Mack Trucks, Inc.
Greensboro, NC USA

Engine VGT Actuator and TSS Sensor Connector, Relocation
CHU, CXU, GU, MRU
MP8

PI0781, Engine VGT Actuator and TSS Sensor Connector, Relocation

(June 2012)

W2072331

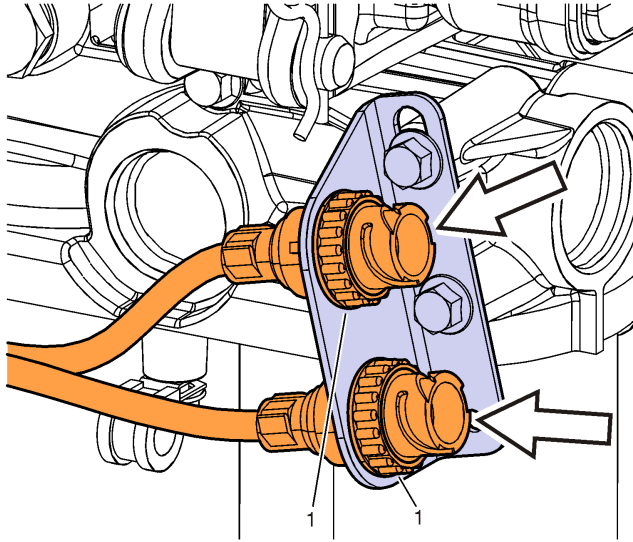
- 5 Remove the engine VGT actuator and TSS sensor connectors from the mounting bracket.

Note: Discard the attachment ring/nut (Item 1).

W2072332

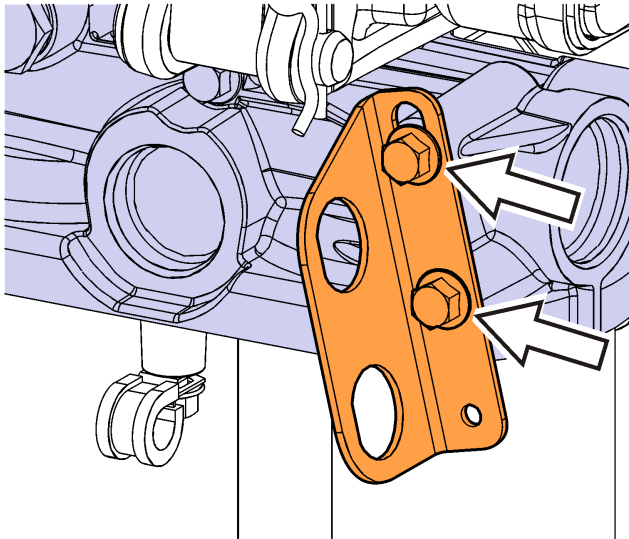
- 6 Remove the connector mounting bracket from oil filter housing.

Note: Discard the mounting bracket.

W2072333

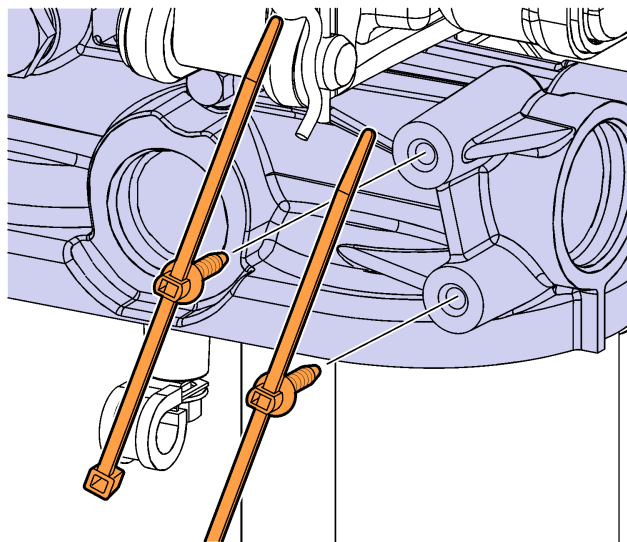
- 8 Install the push-in cable ties (part number 980881) into the M8 threaded holes in the oil filter housing.

Note: Ensure the push-in cable tie flanges are tightly secured against the M8 threaded holes in the oil filter housing.

W2072335

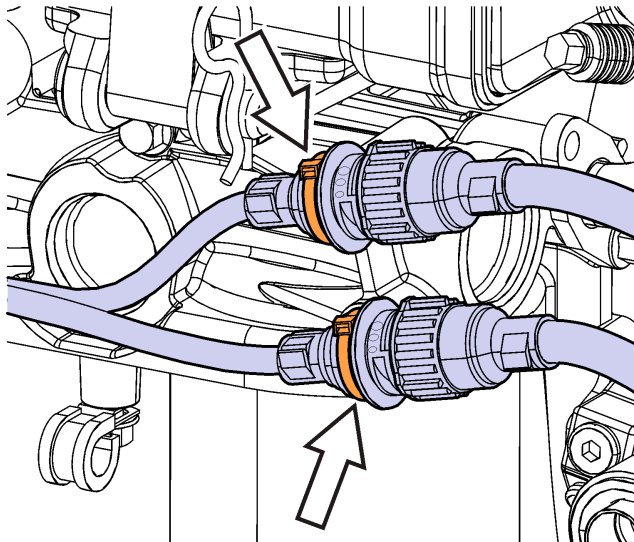
10 Secure both connectors with the push-in cable ties.

Note: Ensure the cable tie is in the end groove between connector flange and back shell as shown in figure below.
